From: Tim Screen
Sent: 23 November 2021 12:02
To: Rebekah Morgan
Subject: 21/03343/F - Land Adj To Promised Land Farm, Wendlebury Road, Chesterton

PROPOSED SURFACING & LANDSCAPE PLAN

REVISION: #
 #1: AJ
 CHECKED: CM
 DATE: 03/09/2021
PLANNING
 Planning Issue
 PLANT DATE:
David Lloyd CLUBS
CATALYST BICESTER
PROPOSED SURFACING & LANDSCAPE PLAN
 DRAWING: TH
 DATE: SEPT 2021
 SCALE: 1:250 @ A1
Hadfield Cawkwell Davidson
 Broomegrove Lodge, 13 Broomegrove Rd, Sheffield, S10 2LZ T 0114 266 8181 www.hcd.co.uk
 Architecture | Engineering | Interior Design | Masterplanning | Urban Design
 2018-260 | A-PL-95-210 | PD
 5:\clients\2018-260\Planning\2021-09-02_amended_planning\04_Paved_Court_A-95-210_P0_Proposed_Surfacing & Landscaping_Plan_01.dwg | 0/102

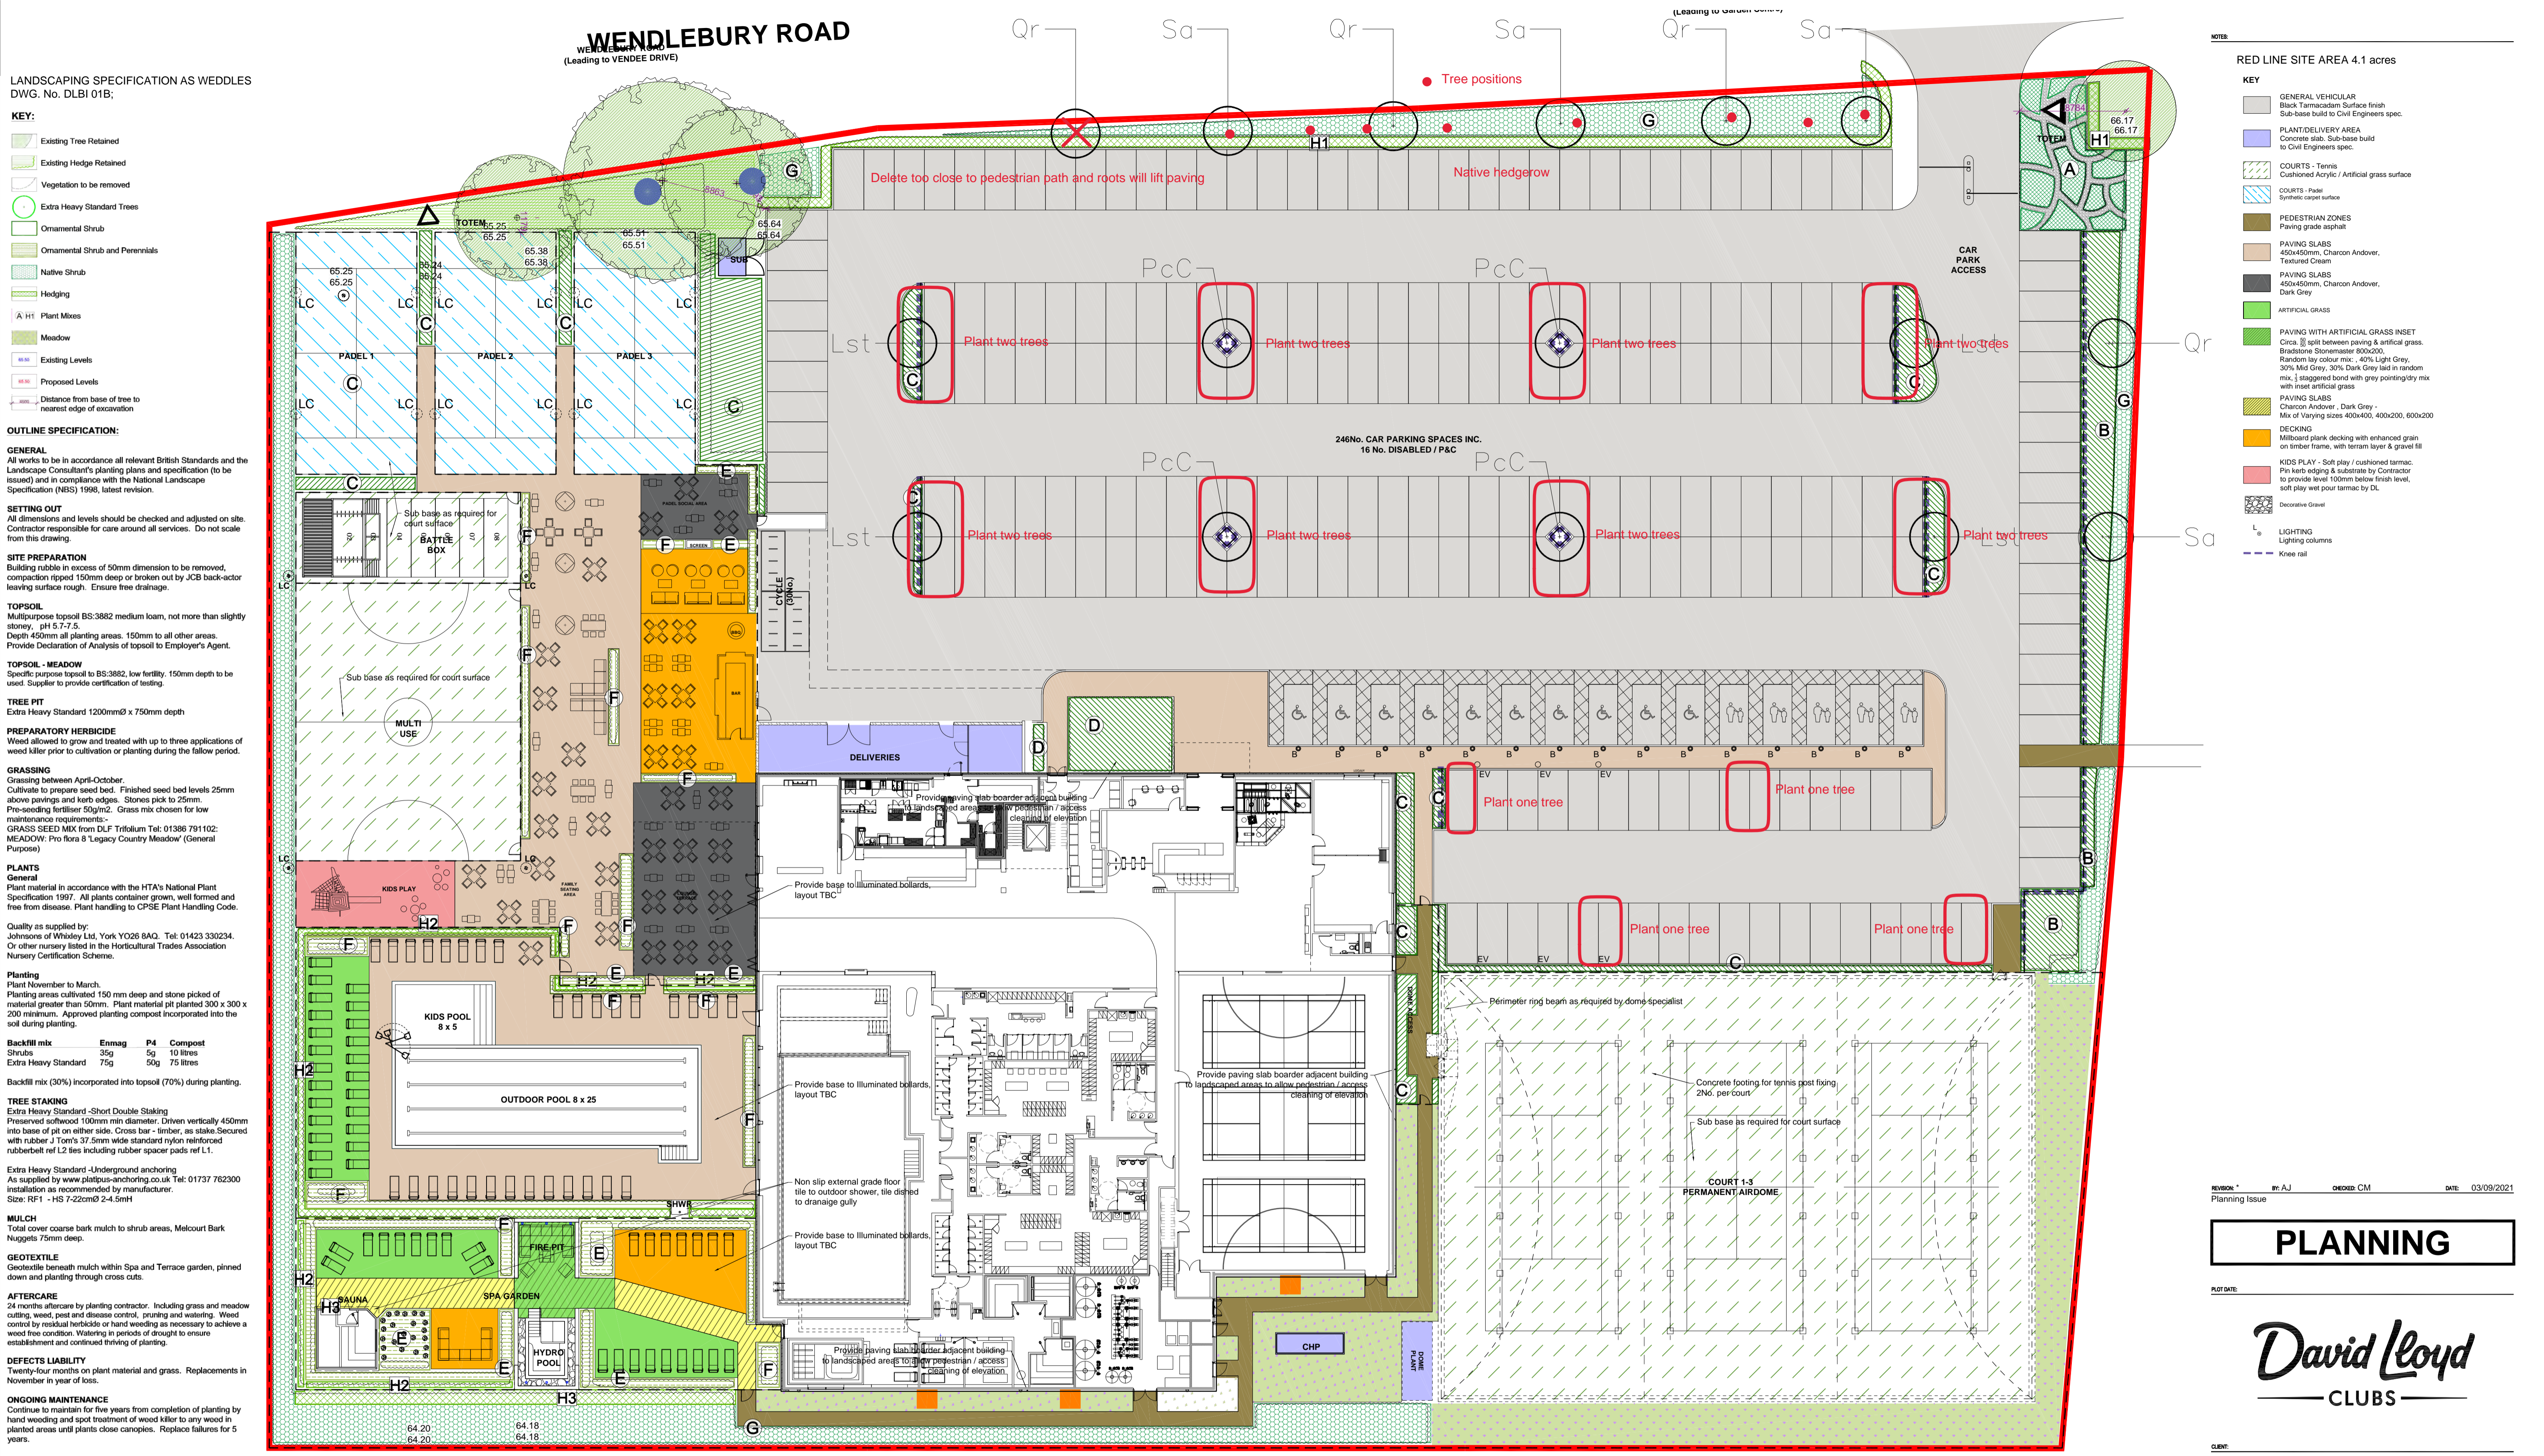
A substantial amount of native structural vegetation has been removed from the frontage of Wendlebury Road for the benefit of highway vis play, roundabout and road realignment and widening. This has exposed the site where visual receptors experience harmful construction impacts, operational and physical impacts of large car park and buildings where once there was an attractive country lane. The proposed *Fagus sylvatica* hedge is too formal and does not have the species (flora and fauna) diversity and visual richness of a native mixed hedgerow, which is required here - not forgetting an improved BREEAM score for the overall development. The mixed native hedgerow will require a 1 m wide wildflower verges on both north and south sides; against the pedestrian route and the car park to allow for the growth of the hedgerow. The regimented row of trees is too formal and irregular spaced native trees in groups are required. The hedgerow should be implemented at the earliest opportunity during the current planting season with appropriate landscape maintenance to aid its establishment and facilitate growth, whilst site clearance and construction proceeds. This will provide some visual benefit, but also reassurances that the construction/operational and visual impacts are being addressed at the earliest opportunity.

The potential 'heat island' effect and the harmful visual impact of such a large car park must be addressed for the benefit of onsite users. Additional, climate enhancing, trees should be planted in the car park where space, services and parking bay numbers allow. It has been established that groups of trees sharing the same larger volume tree pit establish and perform better than single trees in isolated tree pits. I would prefer to see larger tree'ed areas protected by knee rail and understory planting. All trees are to be supplied, handling, planted and established in accordance with the current British Standard BS 8545: 2014 The *Pyrus calleryana* 'Chanticleer' are generally ubiquitous; they are prone to ugly, wound healing deformations to the main stem. Therefore replace this cultivar with *Ginkgo biloba* trees with the more attractive bark. Tree pit details are going to be necessary. Root barriers should be considered and their positions indicated on the landscape proposals.

The proposed trees for open space and street should be appropriate in terms of 'Right Tree Right Place' and I therefore recommend that the landscape consultant to consider TDAG's tree species selection for green infrastructure at the earliest opportunity. Are revised layout should accommodate more street trees to be adopted and maintained by OCC.

The planting distances are incorrect and planting density should be increased for most species. Good ground coverage is required after 2-3 growing seasons. For example the *Potentilla fruticosa* 'Abbotswood' is proposed to be planted at 0.71 m apart which is far too open. I recommend 3 P.f 'Abbotswood' plants per sq. m to achieve the desired effect. All plant densities should be looked at again and the nos/sq. m rule imposed.

There is no instruction to plant in species groups or drifts of 3, 5 or 7. This appears to be left to the landscape contractor during site operations. There is even no instruction to ensure the species are not planted too close to the edge of borders. This may happen, whereas species grow over the path they will be unsympathetically pruned.

Plant bed C border between the car park the dome is too narrow for effective establishment of plant species, and will be overshadowed by the dome. There will be insufficient topsoil and drainage because the concrete haunching to retain the edge of the paving and playing surface will be very substantial. Delete this border and replace with free-draining gravel surface. The dome and the adjoining car park are visually onerous and tree planting in the car parking is appropriate to visually mitigate these elements.

The maintenance proposals should be clarified with current British Standards – refer enclosed crib sheet.

The Landscape Management notes on the drawing are limited in their explanations and must be confused with the more detailed LEMP. These notes should therefore be deleted off the drawing. Shrubs should be pruned at the correct times to enhance flowering and the production of fruits for visual appeal and food source for birds. For the proposed trees there should be inspections, hand weeding, mulching, stake and tie adjustment, formative pruning and ground moisture monitoring and watering at appropriate times, all in accordance with BS 8545. It should also mention that dead, dying and diseased trees are to be replaced.

Revised landscape proposals are required along with tree pit details/specifications.
